- Change of mounting nut
- Change of material
- Change of product design

Product Change Notification					PCN FEC, FIZ, FUL Change of mounting nut			
owner	creation date	release date	released by	change order	rev	page	D40 074 454	
kraftal	07.02.2023	27.02.2023	schulejo		Α	1 of 2	D10-071-154

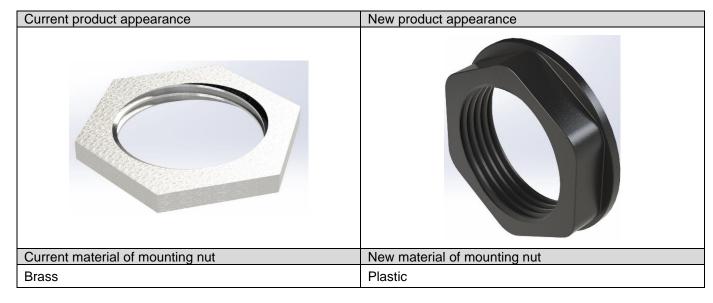
- · Change of mounting nut material, mounting torque remains
- Max. panel thickness reduced by up to 3mm

\boxtimes	Form	No action required, plastic instead of metal nut
\boxtimes	Fit	Consider new max. panel thickness
	Function	
	Manufacturing	
	Label	
	Packaging
